CITY OF DE PERE

ADDENDUM NO. 1
PROJECT 22-11
2022 UTILITY AND STREET CONSTRUCTION WATERVIEW HEIGHTS FIFTH ADDITION

CHANGES TO PROJECT BID DOCUMENTS:

CHANGES TO PLANS:

SHEET NO.
38R

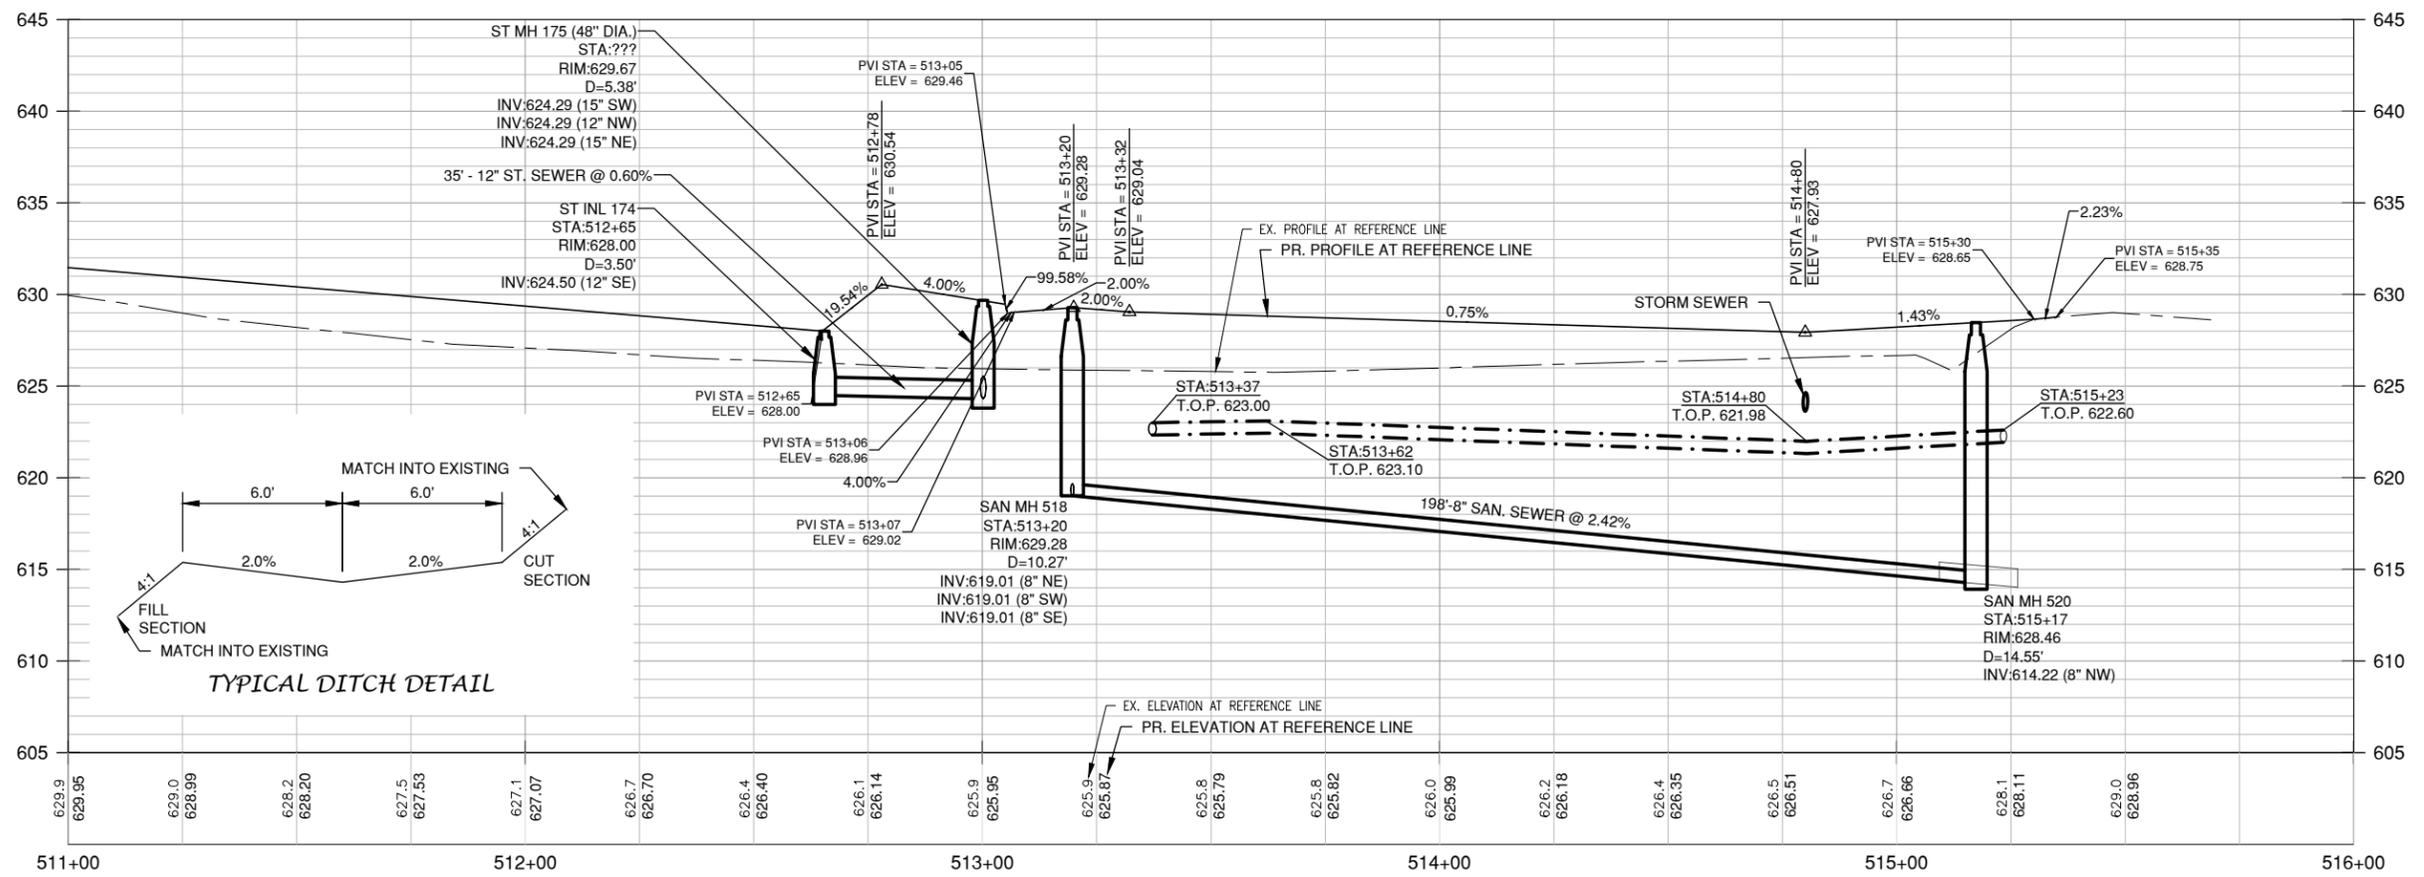
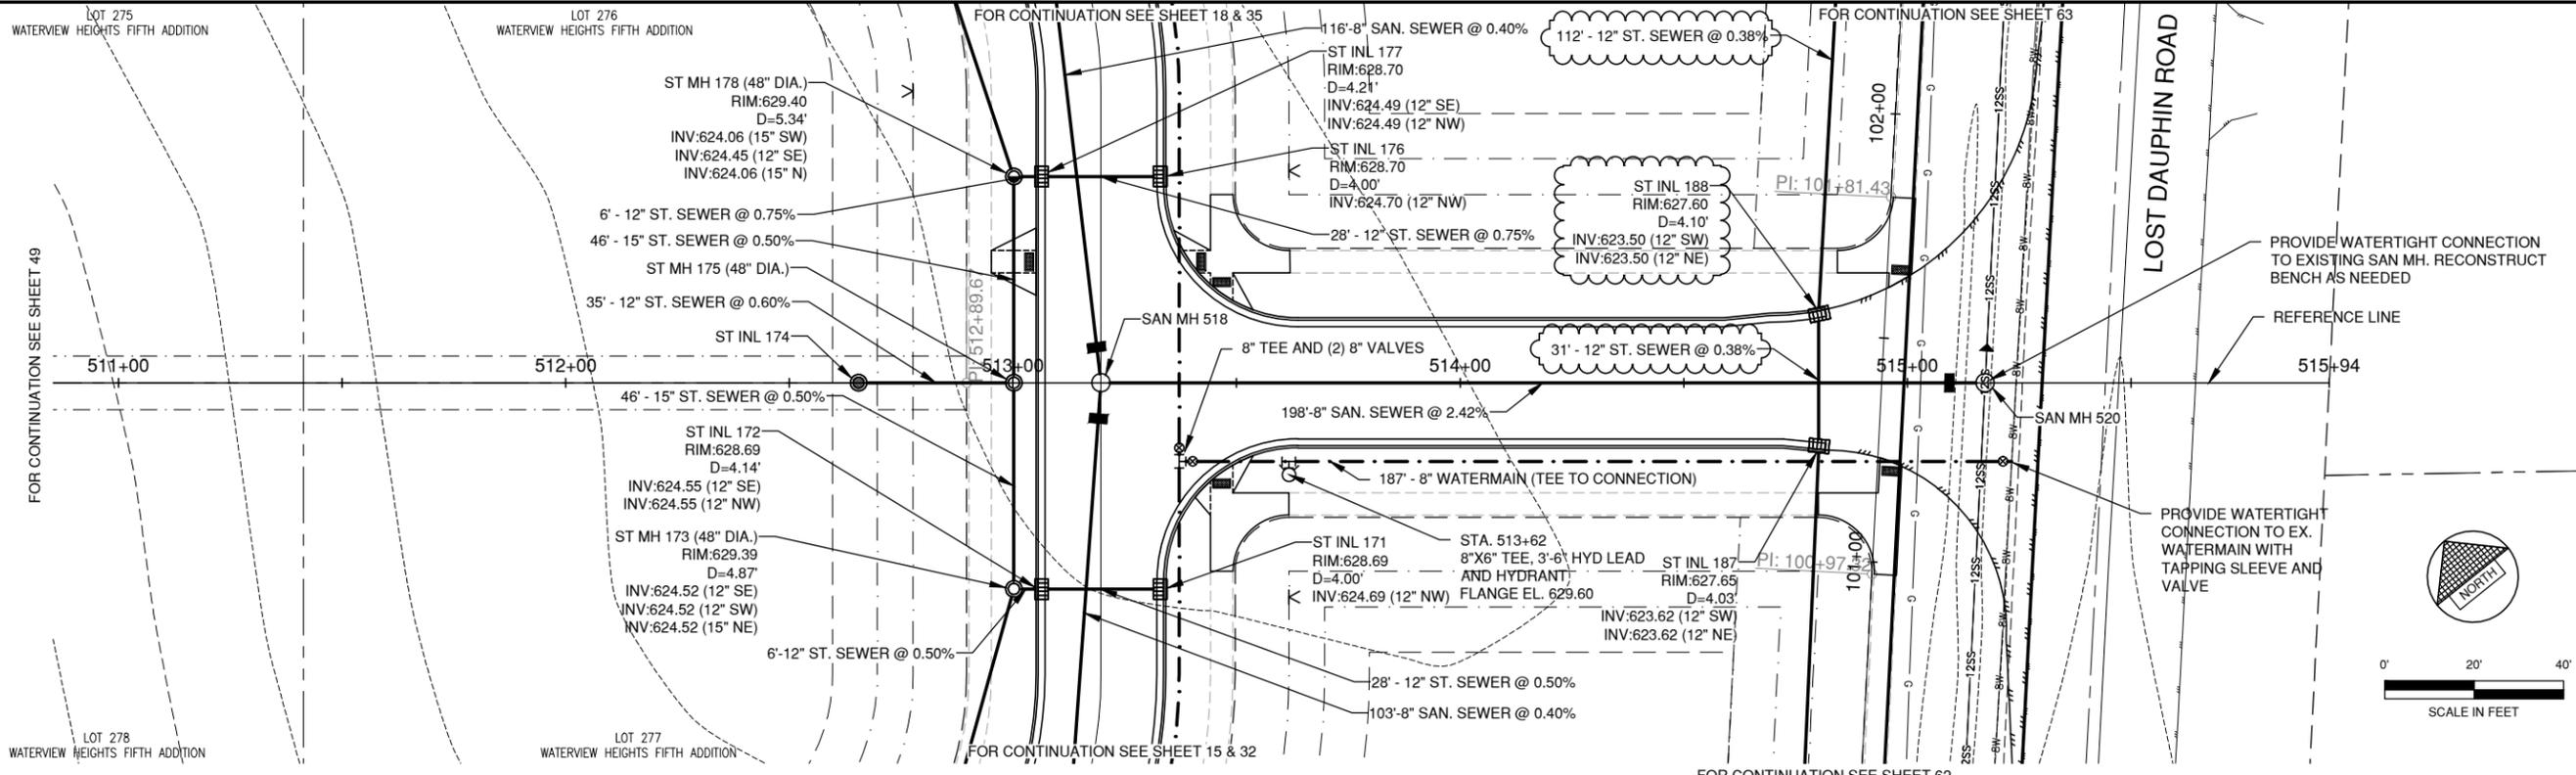
NO.	DATE	APPROV.	REVISION	NO.	DATE	APPROV.	REVISION
1	6/28/22	BDR	STORM SEWER ADJUSTMENTS

BID SET
 SHEET NO.
50R

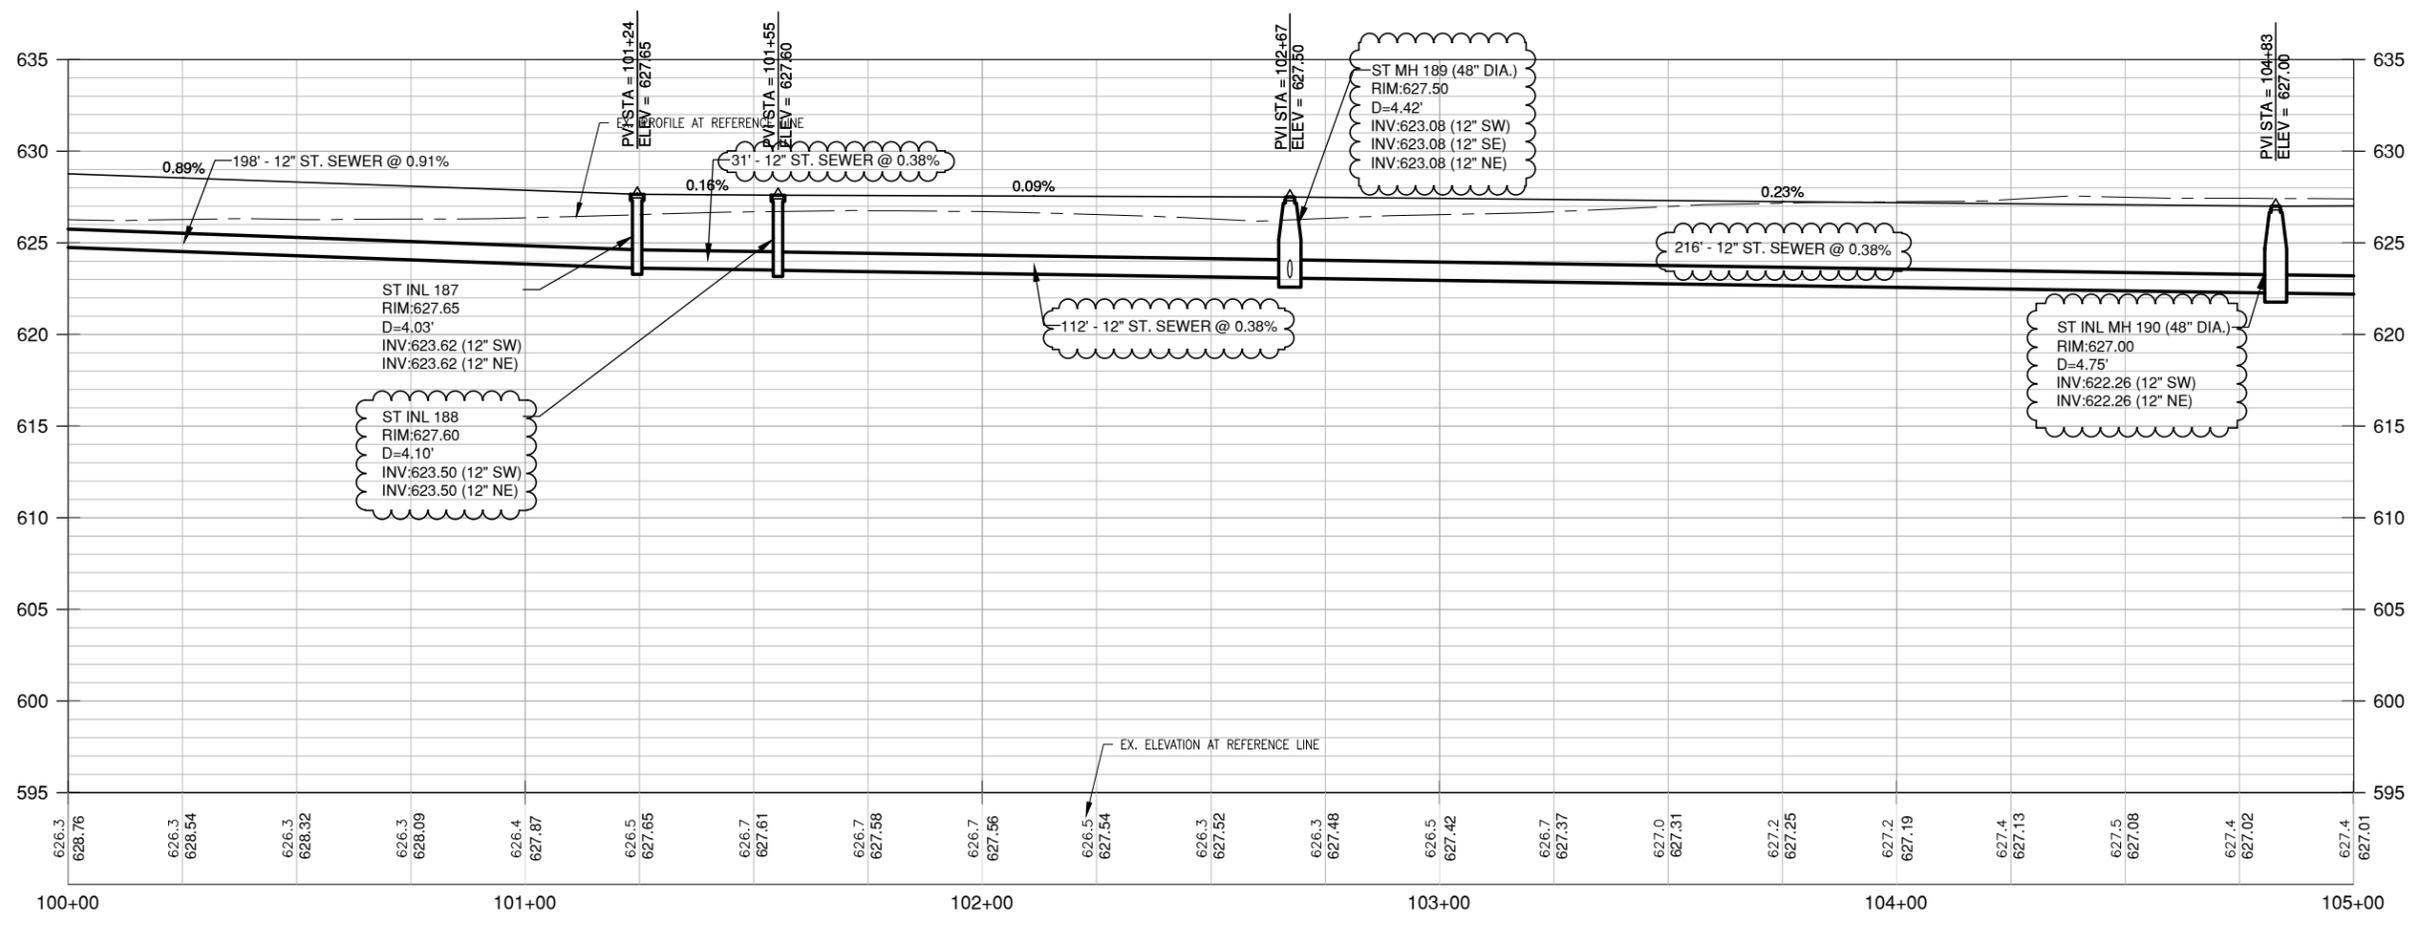
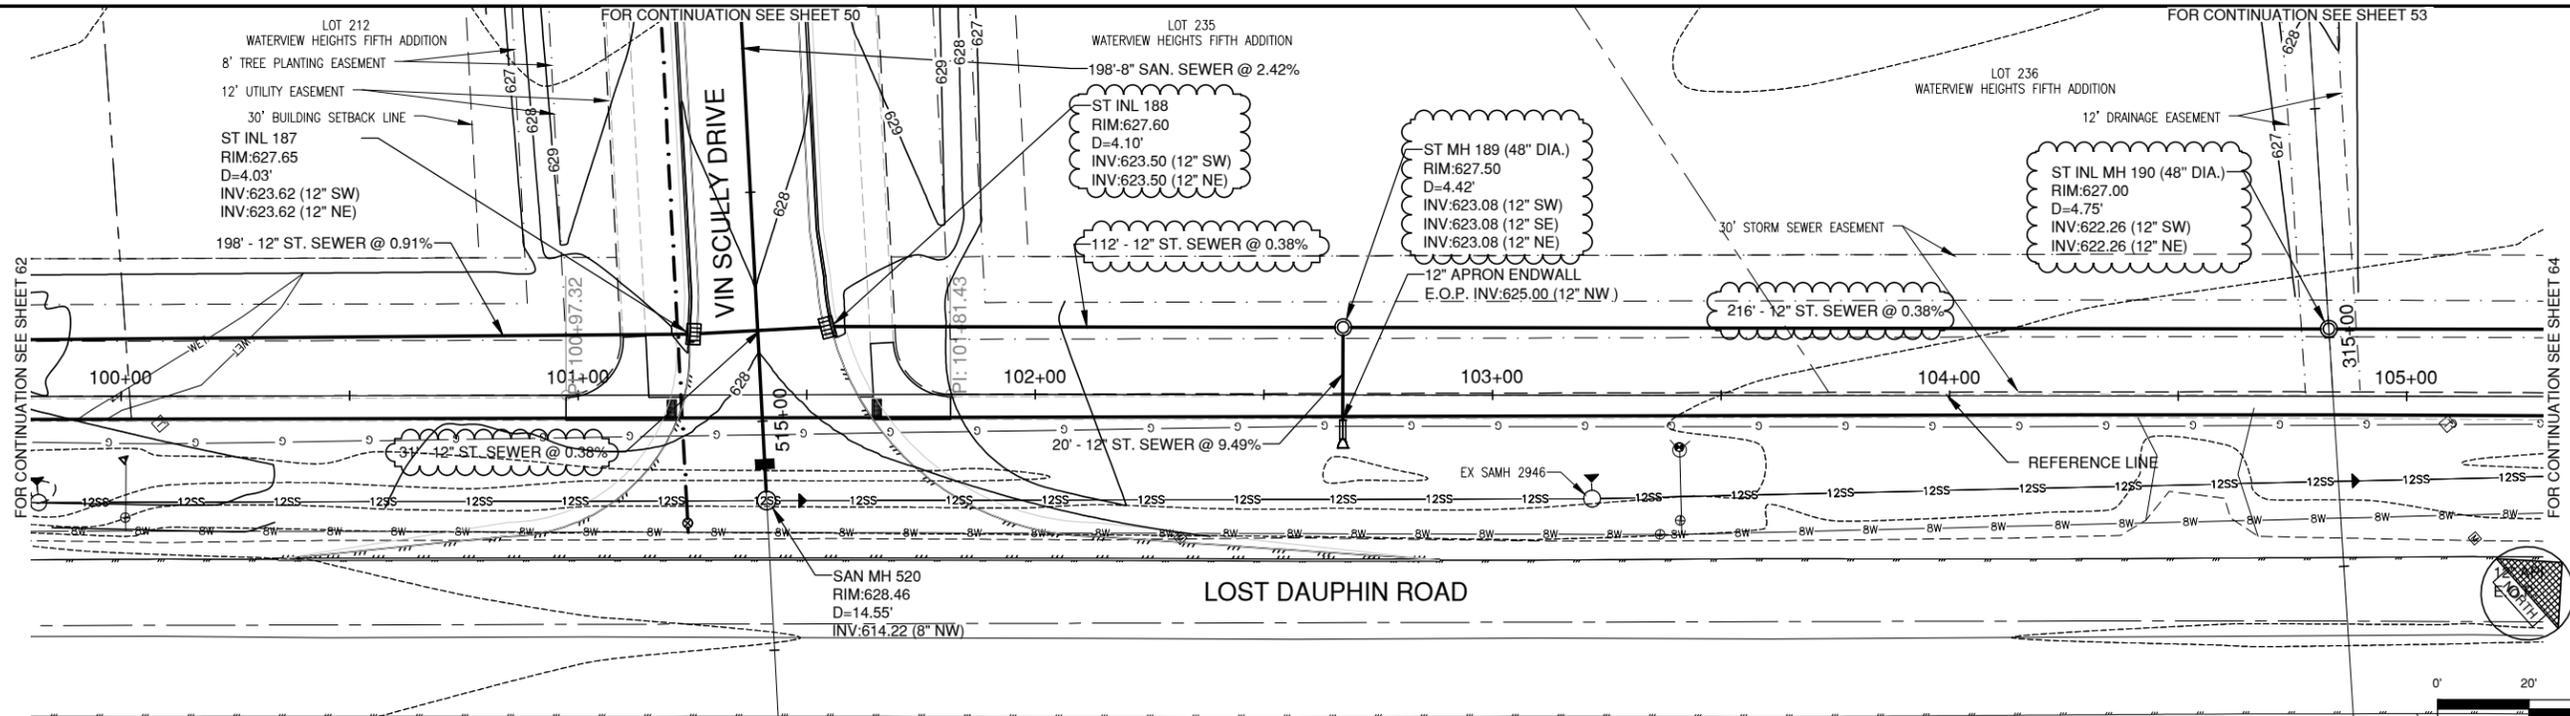
NO.	DATE	APPROV.	REVISION	NO.	DATE	APPROV.	REVISION
1	6/28/22	BDR	STORM SEWER ADJUSTMENTS
